Squeaking Noise –
Power Steering System –
Flush System

MODEL 2002-04 MY
X-TYPE

Remove and destroy Bulletin XT211-01, dated 4/02.
Replace with this Bulletin.
Revisions are marked with a bar and in **bold text**.

ILLUSTRATION 1

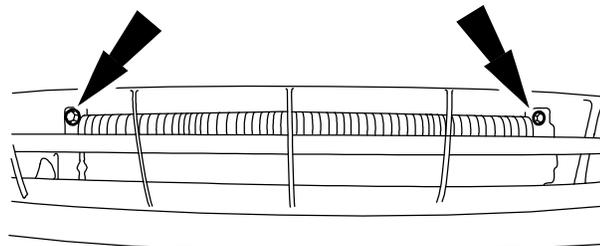
1. Open door.
2. Open hood, fit fender protector covers.
3. Remove PAS reservoir filler cap.
4. Raise vehicle on lift.
5. Remove radiator splash shield (See Workshop Manual, JTIS CD ROM, Section: 501-02, SRO 76.22.90).
6. Remove the bolts securing the PAS fluid cooler (Illustration 1).
